OAK RIDGE NATIONAL LABORATORY

November 16, 1983

RE: Edgemont Mill, Docket #40-1341

Figure 16. Depth-area-duration relationships. Percentage to be applied to 10 square miles, 6-hour probable maximum precipitation values. 288-D-2450.

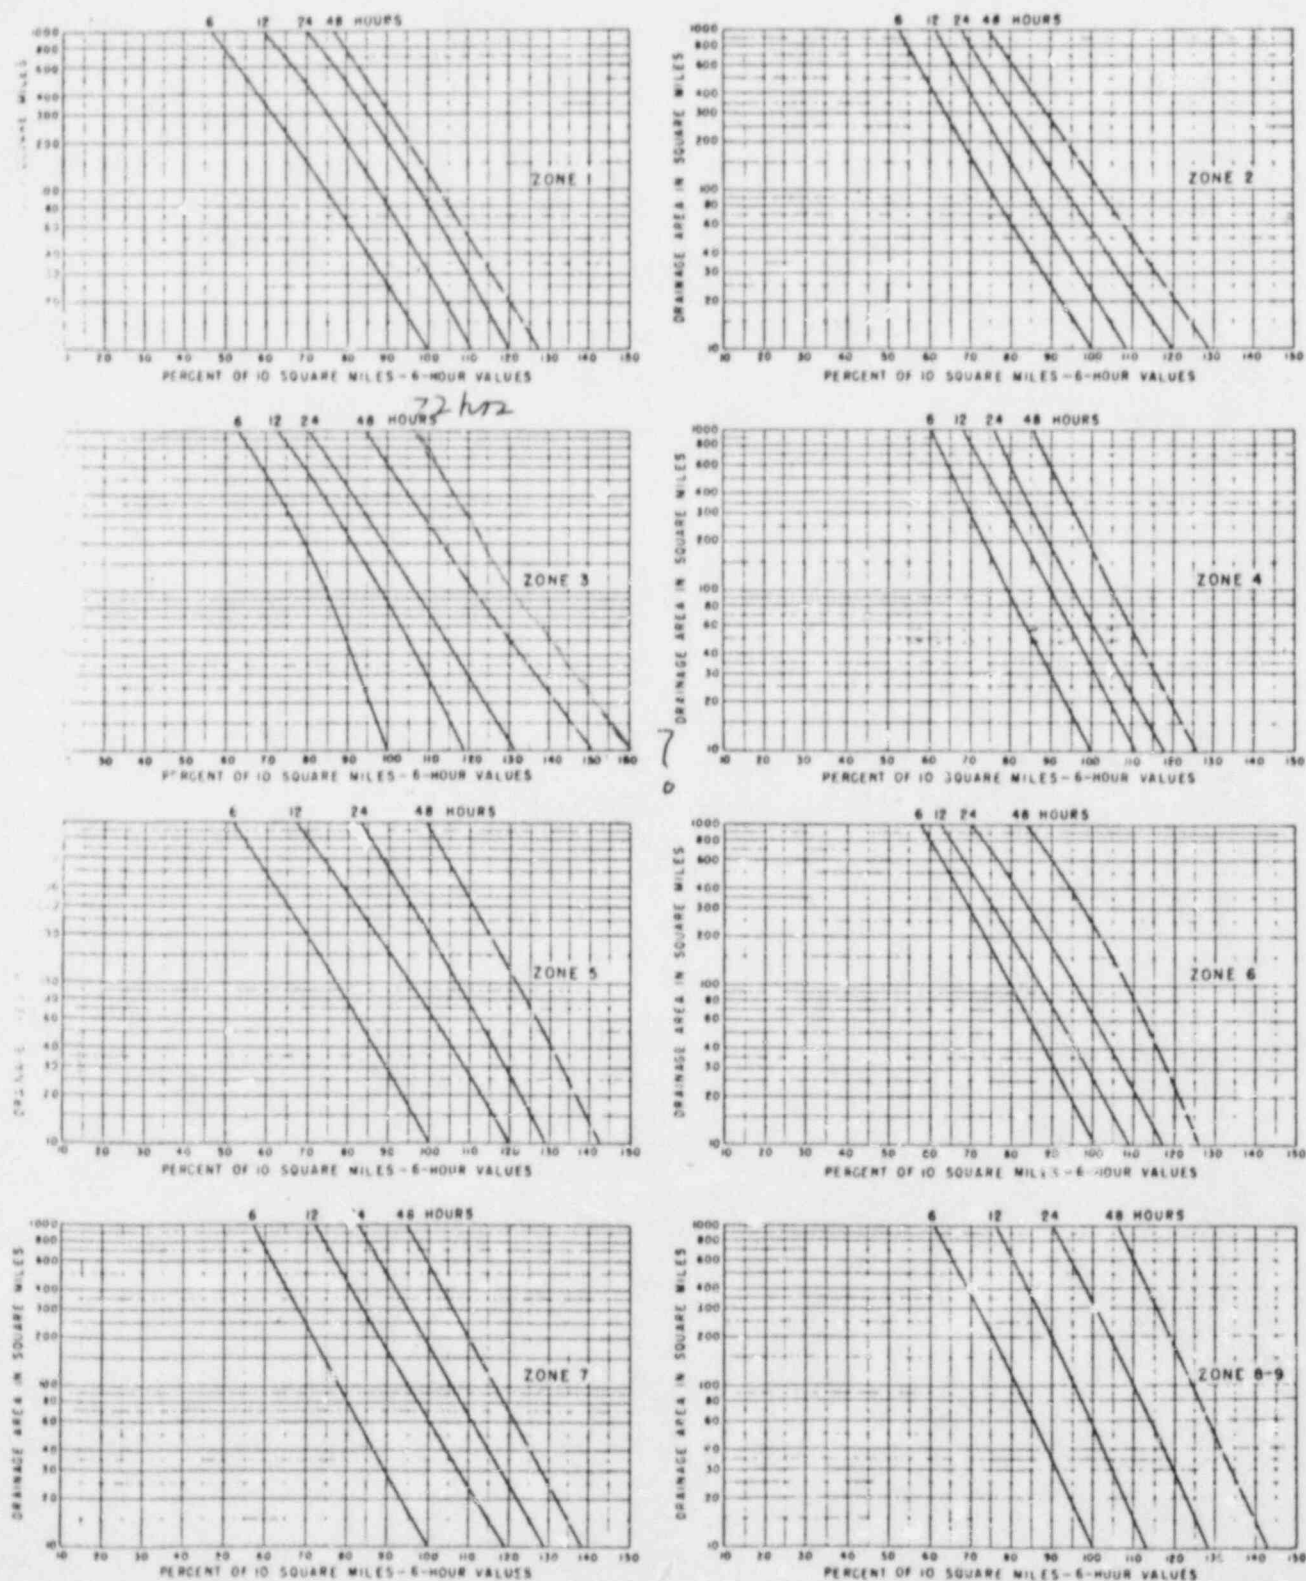
I have reviewed TVA's analysis of the impact of the "probable maximum precipitation" (PMP) on operation of Pond #10 at Edgemont. Although my numbers are larger than TVA's for the PMP (20" versus 16" of rain for a 6-hour duration storm at Edgemont, see enclosed figures), I agree with TVA's end result. Pond #10's capacity is capable of storing the PMP if maximum operating capacity of 50 acre feet is observed and TVA can verify that the catchment area adjacent to the haul road is no greater than 19 acres. A properly scaled map showing drainage divides should suffice for this purpose.
